Docket Item # 14 & 15  
BAR CASE # 2011-0224/225

BAR Meeting  
September 7, 2011

**ISSUE:** Permit to Demolish/Encapsulate and Addition/Alterations

**LOCATION:** 317 South Union Street

Figure 2. Proposed side (north) elevation.

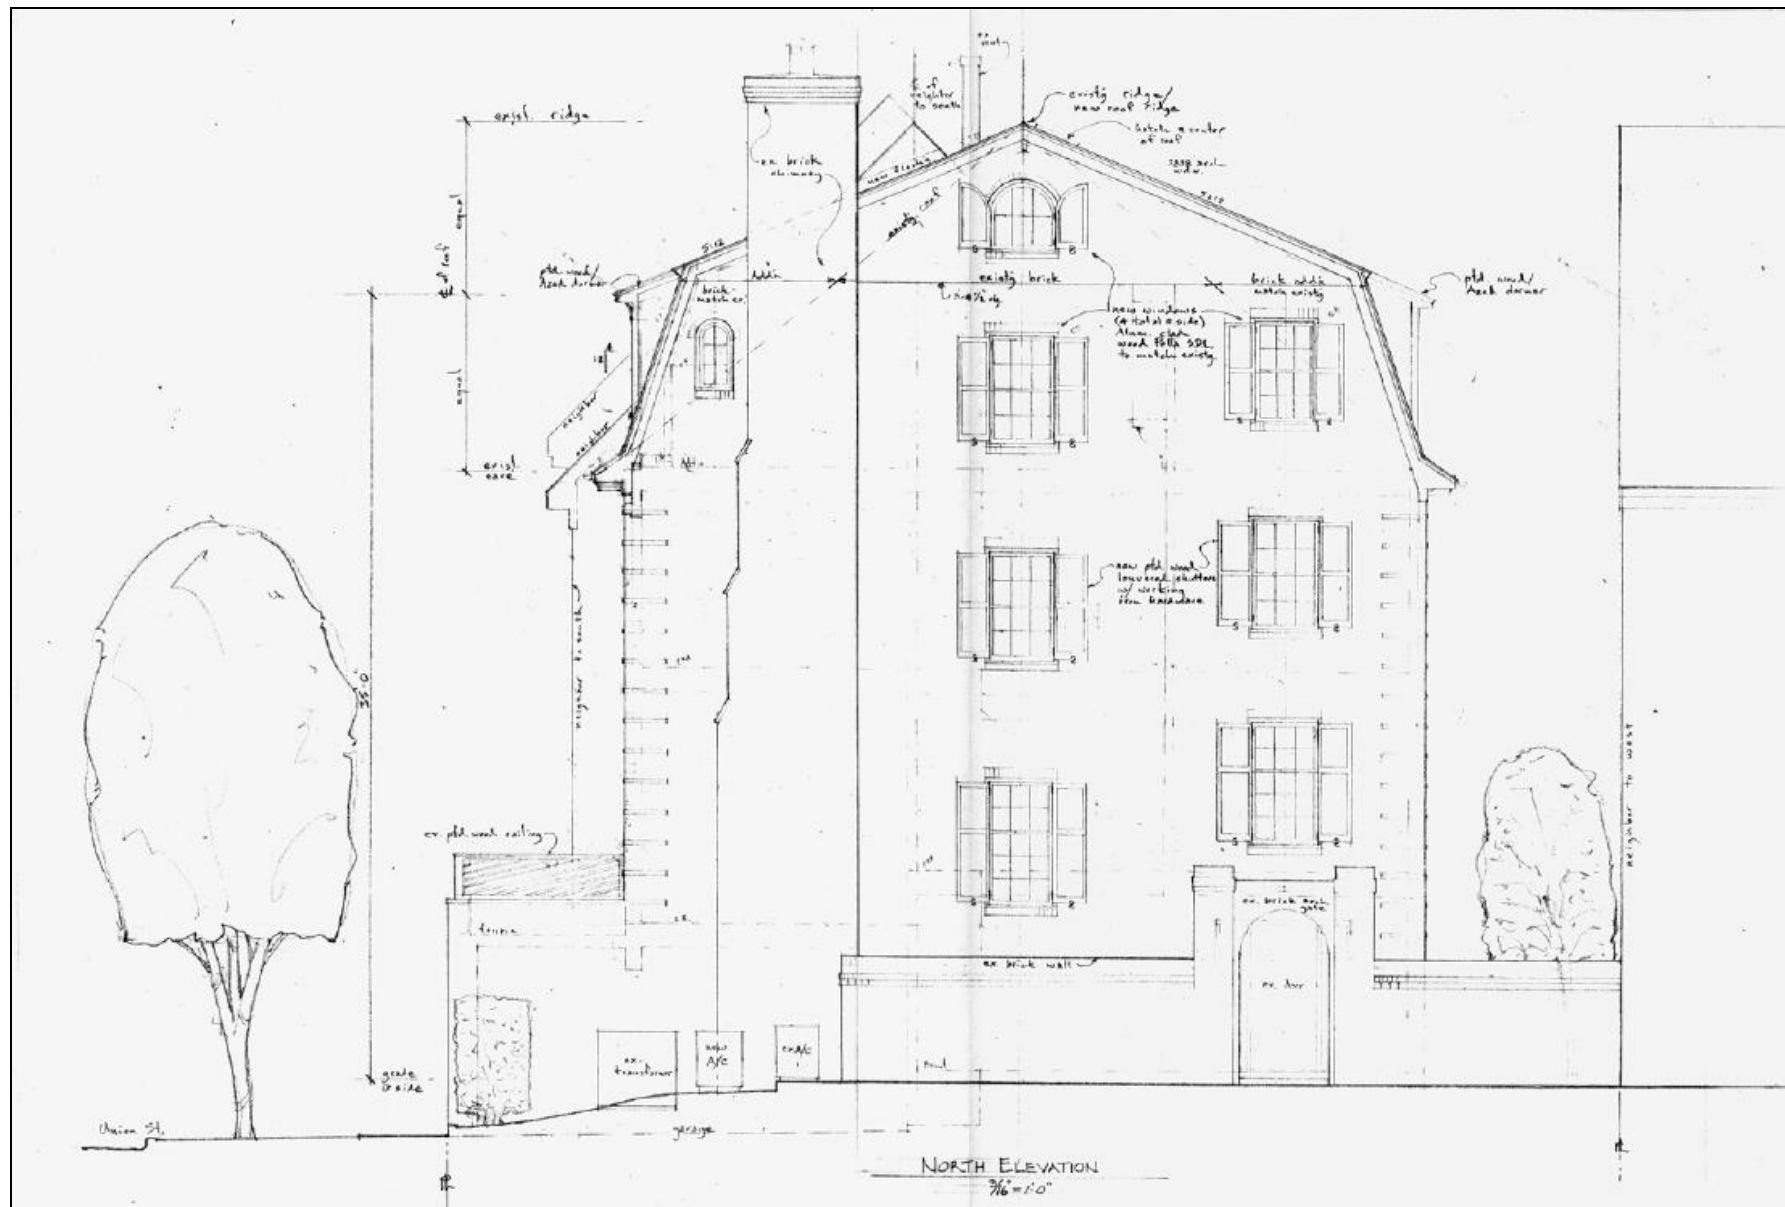
- On side (north) elevation, the existing oriel window will be replaced and four new windows will be added (two six-over-six, double-hung windows; a single six-light arched window in the approximate location of the oriel window; and a six-light arched casement window adjacent to the chimney. The new gambrel roof will be clad in synthetic slate. The dormer trim and cornice will be painted wood or Azek. The proposed windows will be aluminum-clad wood windows. The brick on the north elevation will match the existing.
